U7-C-STP-NRC-100155

South Texas Project
Units 3 and 4
Docket No. PROJ0772
Responses to Request for Additional Information

Reference: Letter from Tekia Govan to Mark McBurnett, "Request for Additional Information Re: South Texas Project Nuclear Operating Company Topical Report (TR) WCAP-17116-P Revision 0, Supplement 5 – Application to the Advanced Boiling Water Reactor" (TAC No. RG0012), June 7, 2010 (ML101580249)

Figure 7-1 Comparison of Responses for DEG and Split of the Same Area (Steam Line Break)

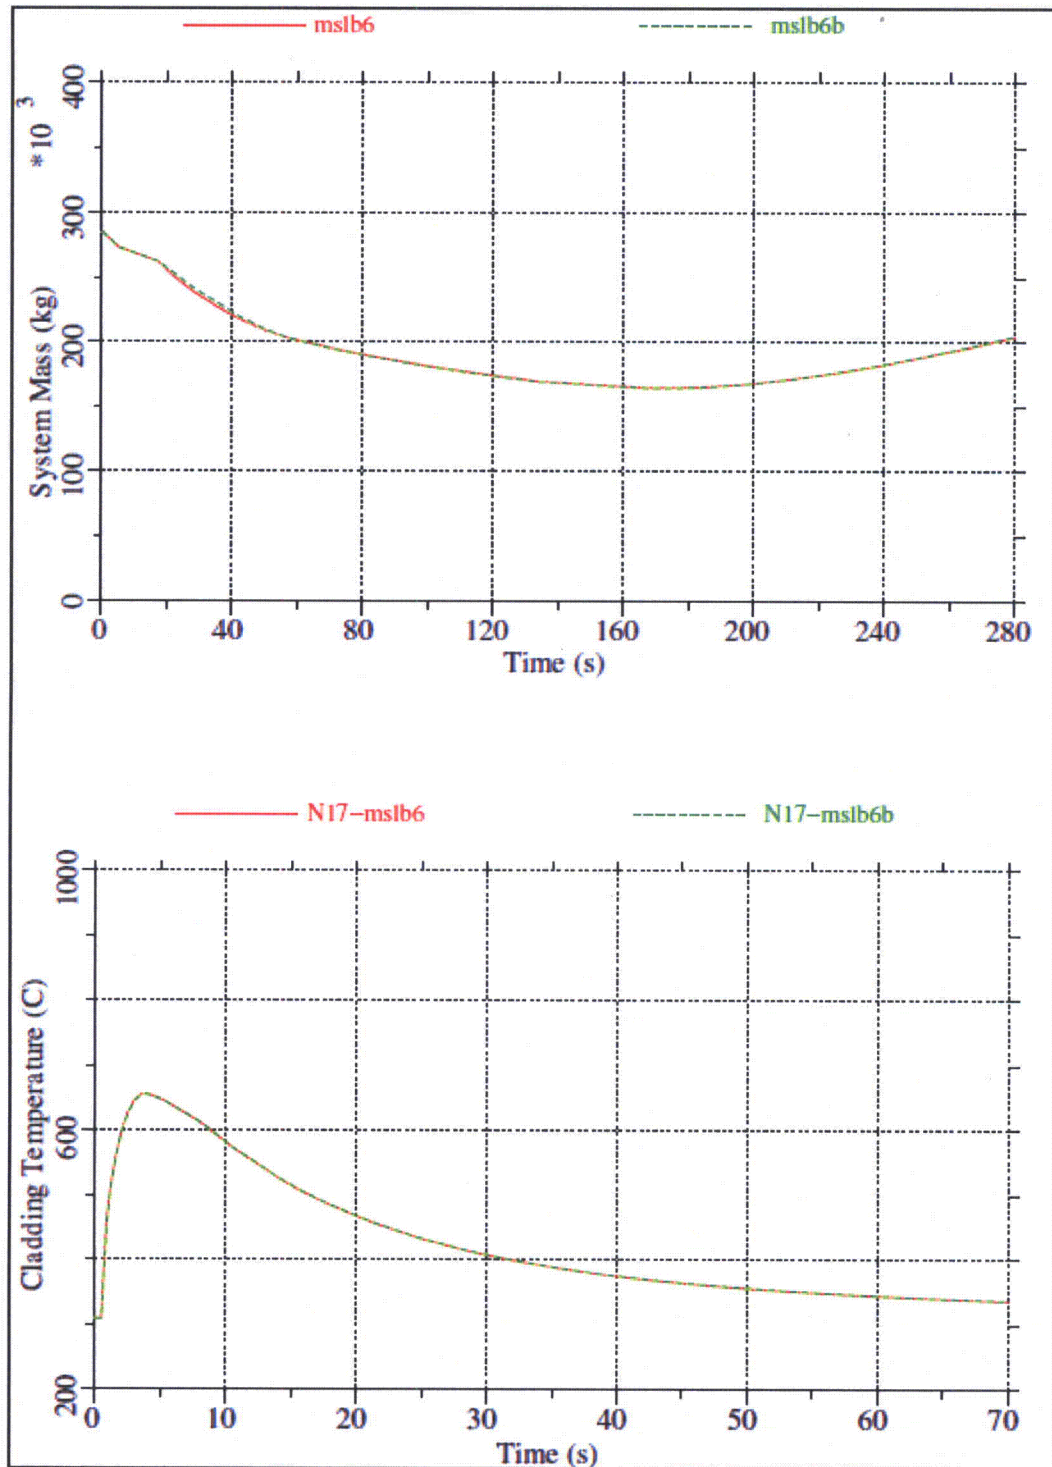
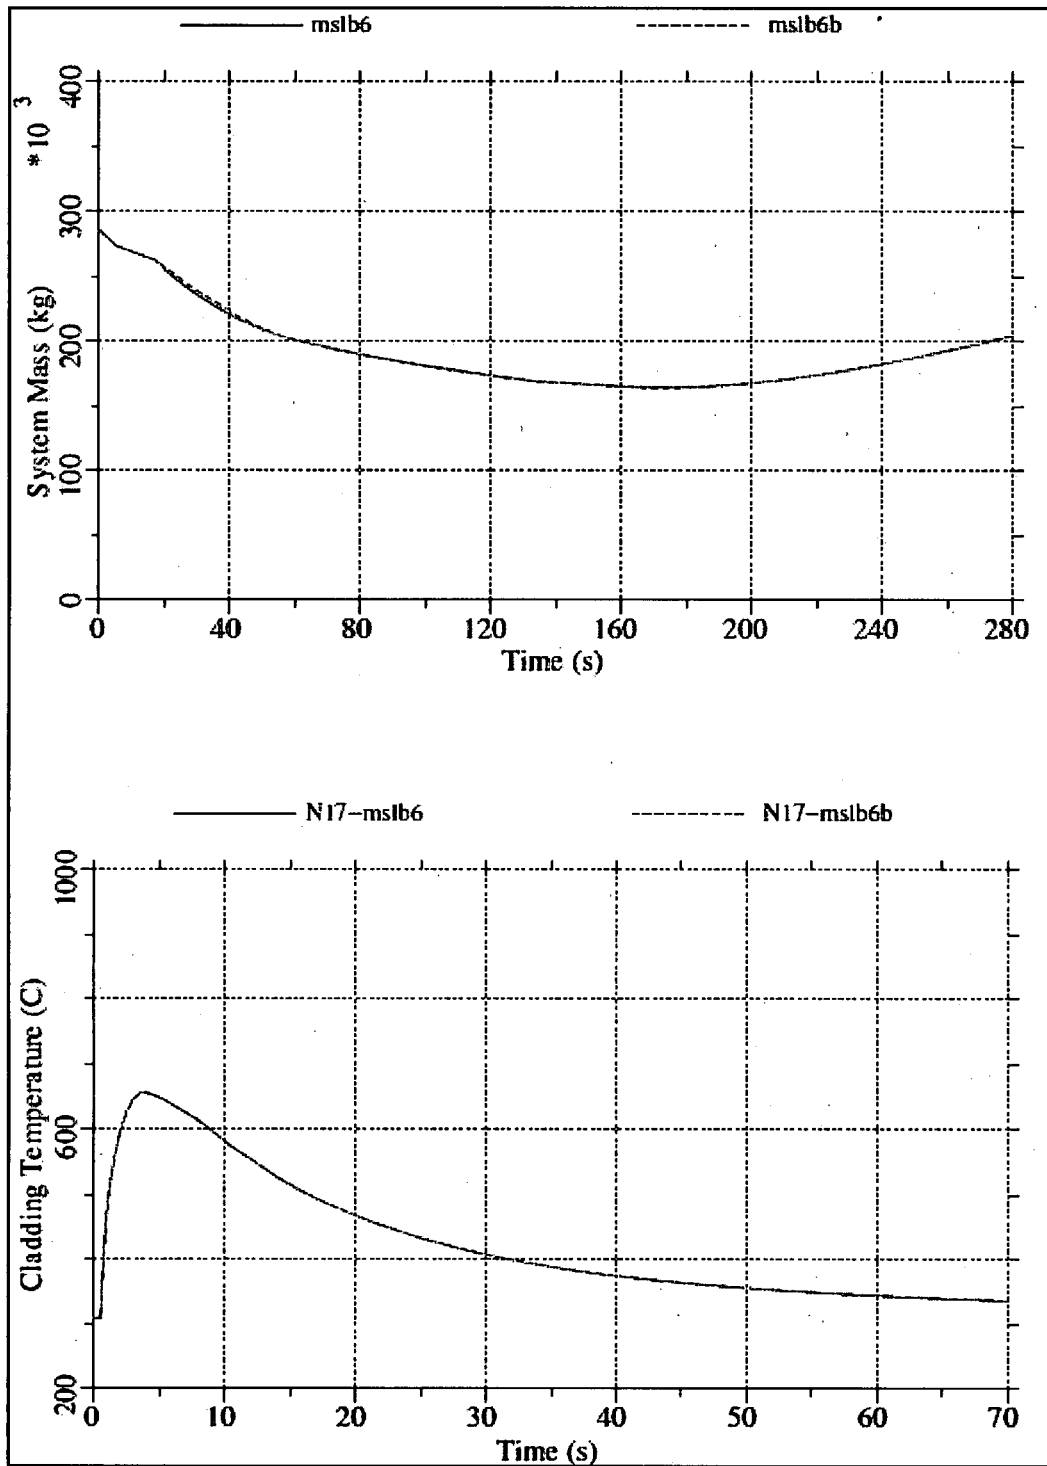
In Section 6.3.1.1 of WCAP-17116-P, it is stated that the break spectrum analysis for ABWR includes a series of double-ended guillotine and longitudinal split breaks, in compliance with I.C.1.a of Appendix K. In the text of Sections 4.5 and 4.6 of WCAP-17116-P, some of the break spectrum scenarios were double-ended guillotine breaks and the rest were not identified clearly in this respect. Specify to which class of break each of the break spectrum scenarios in Sections 4.5 and 4.6 belongs.

The results of longitudinal split breaks were not reported in the LTR. However, a sensitivity study (case mslb6b) was performed for a steam line break wherein a split break was assumed to occur having the same combined break area as the comparable double-ended guillotine break (case mslb6), which is described in Section 4.5.2.1. Figure 7-1 compares the total system mass and the peak cladding temperature predicted by GOBLIN for the hot assembly. As shown, the system responses were essentially identical. This result is expected because the break flow from the reactor vessel is limited by the integral flow restrictors in the steam line nozzles and the flow returning from the intact steam lines is quickly isolated by the Main Steam Isolation Valves (MSIVs).
